IRF19/1759

Gateway determination report

LGA	City of Parramatta
PPA	City of Parramatta Council
NAME	18 - 40 Anderson Street, Parramatta (289 dwellings and an additional 90 jobs)
NUMBER	PP_2019_COPAR_002_00
LEP TO BE AMENDED	Parramatta Local Environment Plan 2011
ADDRESS	18 - 40 Anderson Street, Parramatta
DESCRIPTION	Lot 20 DP792518
RECEIVED	27 August 2019
FILE NO.	IRF19/1759
POLITICAL DONATIONS	There are no donations or gifts to disclose and a political donation disclosure is not required.
LOBBYIST CODE OF CONDUCT	There have been no meetings or communications with registered lobbyists with respect to this proposal.

Figure 7: Site zoned B3 Commercial Core under draft Parramatta CBD planning proposal (Source: City of Parramatta)

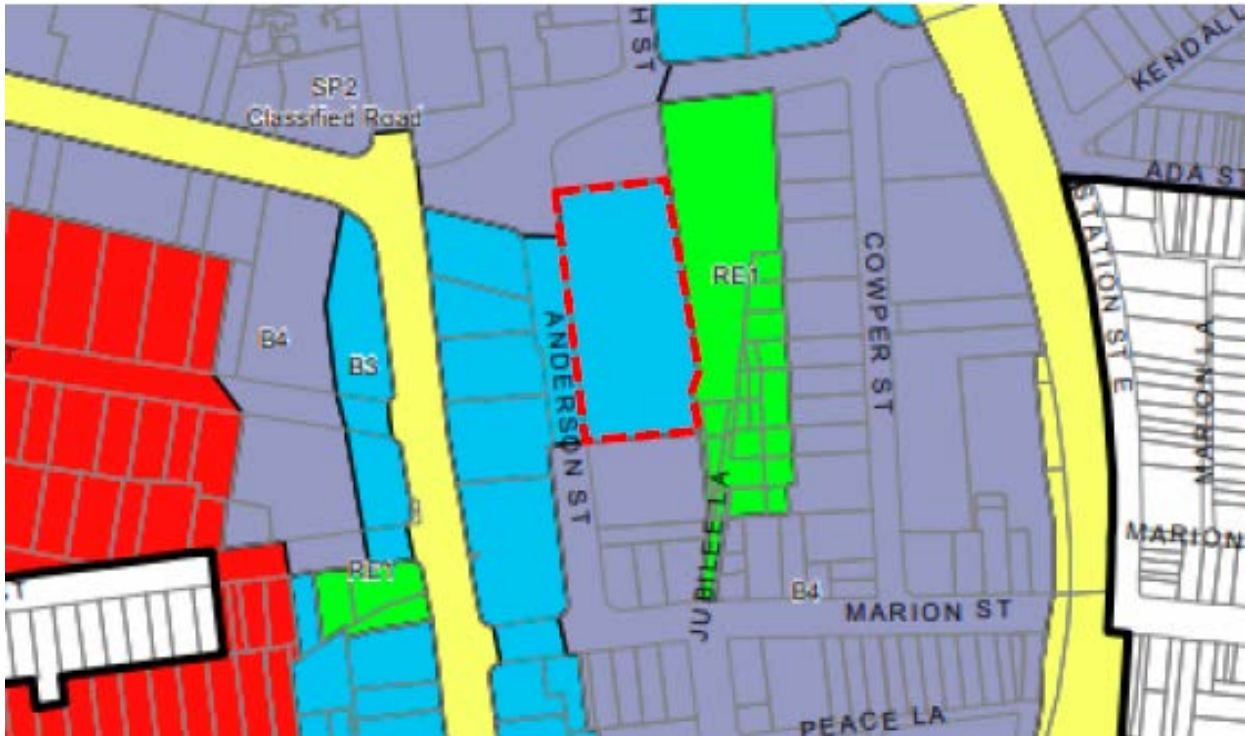
The proposed B4 Mixed Use zone under the subject planning proposal is inconsistent with the B3 Commercial Core zone as identified under the draft Parramatta CBD planning proposal (**Figure 7**).

Council has identified that the B3 Commercial Core zone identified under the Parramatta CBD planning proposal was primarily a response to the site's flood risk, which was considered to make it unsuitable for residential use. It is noted that tourist and visitor accommodation is permissible in both the B3 Commercial Core, B4 Mixed Use zone and the existing B5 Business Development zone.

An updated and site-specific flood impact assessment (**Attachment F**) submitted as part of the subject planning proposal demonstrates that the site, in principle, is suitable for residential development, supporting the B4 Mixed Use zoning.

Figure 8: Draft Height of Building Map in Parramatta CBD Planning Proposal, subject site bound in red (Source: draft Parramatta CBD planning proposal)

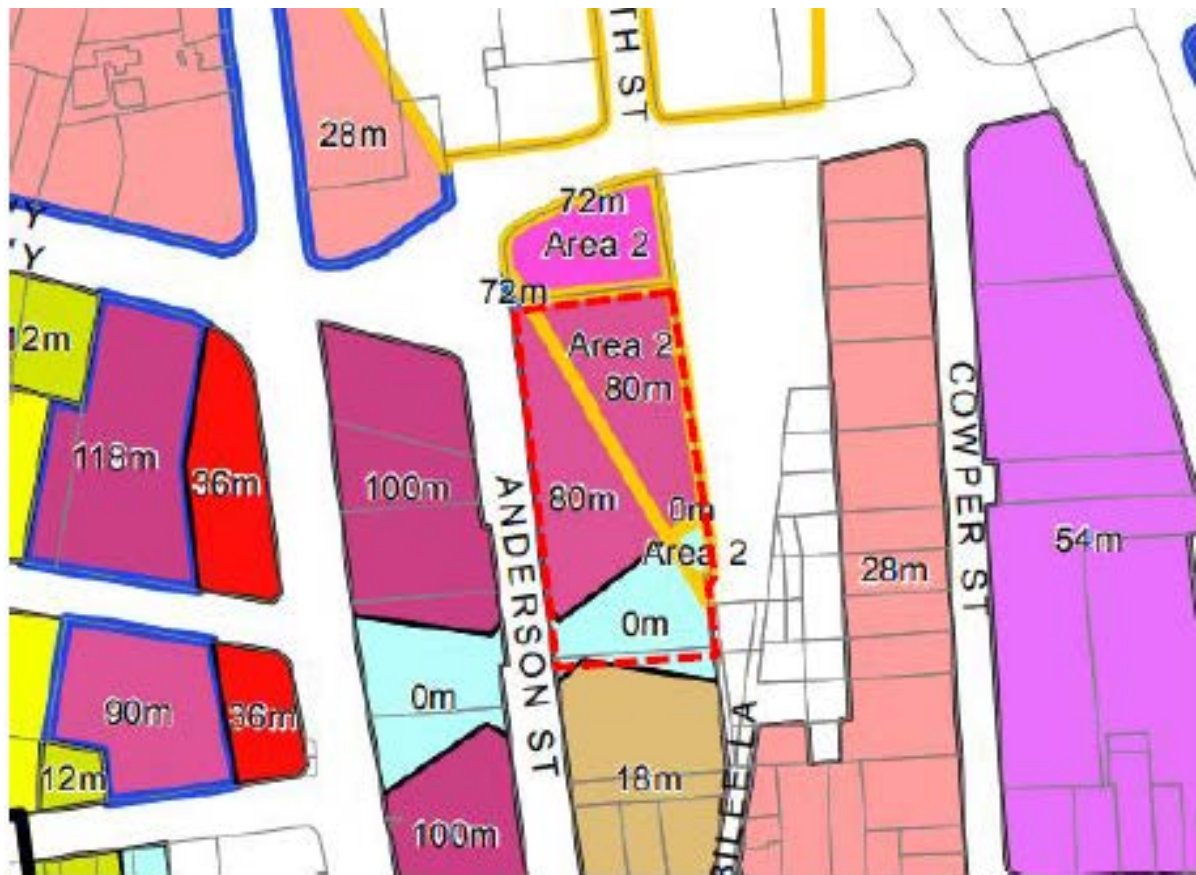
The draft Parramatta CBD planning proposal seeks a maximum height of part 80m and part 0m for the site (**Figure 8**). The proposed 0m portion of the site reflects Council's desire for the land to be dedicated to Council for the delivery of new open space. The planning proposal is consistent with the 0m height under the draft Parramatta CBD planning proposal and would accommodate the open space and through-site link planned for the southern portion of the site.

The proposed 120m maximum height under the subject planning proposal is inconsistent with the 80m proposed under the draft Parramatta CBD planning proposal. Council's Urban Design Team has undertaken preliminary modelling as illustrated in **Figure 9** which suggests that a 120m tower can be accommodated on the subject site, by providing additional height to the southern tower. The site-specific provision to be included as part of the subject planning proposal relating to overshadowing of Jubilee Park will reinforce the solar access protection to the public open space.

It is recommended that the urban design report be updated to reflect the additional height to enable further testing of this outcome, noting that this should also reflect the design excellence bonus (discussed further below).

Figure 11: The proposed design concept (Source: Grimshaw, 2019)

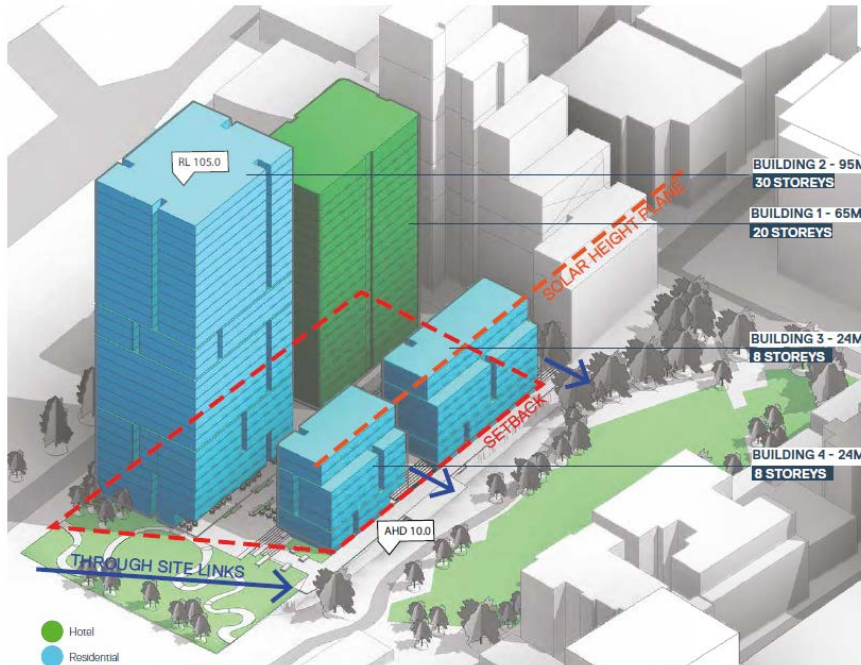
The design reference indicates a height of 95m which is inconsistent with the requested building height of 120m. As a condition of Gateway determination, it is recommended that the urban design report be amended to address the proposed maximum building height of 120m to understand the relationship of the proposed built form to the surrounding area.

It is recommended that prior to public exhibition, Council is to update the urban design report with an additional set of concept plans to identify a maximum building height of 138m. The purpose of these concept plans is to understand the overshadow impacts, particularly on Jubilee Park, and the relationship of the proposed built form to the surrounding area.

Figure 12: Sun access plane diagram – Jubilee Park (Source: City of Parramatta – Parramatta City Centre DCP)

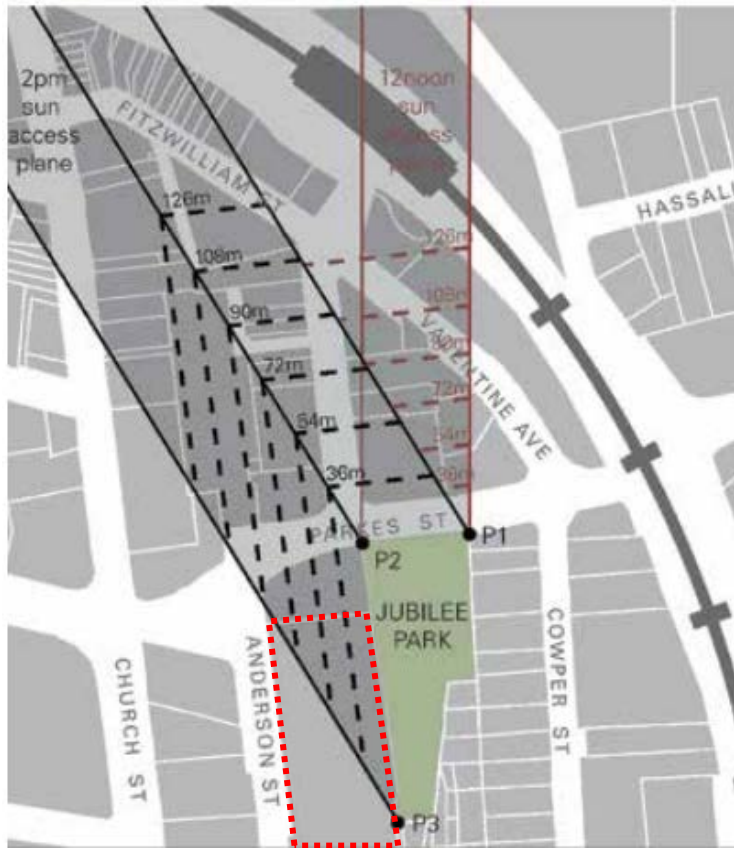
The subject planning proposal proposes a site-specific provision requiring protection of Jubilee Park from overshadowing. In **Figure 12**, the sun access plane generated for Jubilee Park on June 22 between 12 noon and 2pm extends across the site and to the north. Shadow analysis (**Attachment E**) has been provided to demonstrate compliance with the sun access plane controls in the Parramatta LEP 2011 and DCP 2011. However, overshadowing analysis demonstrated in **Figure 13** responds to a height of 95m and does not correlate to the maximum height sought through the proposal.

It is recommended, prior to public exhibition the shadow analysis be amended to respond to a maximum height of 120m. The updated diagram should present any overshadow impacts on Jubilee Park and the proposed green link between Anderson Street and Jubilee Park.
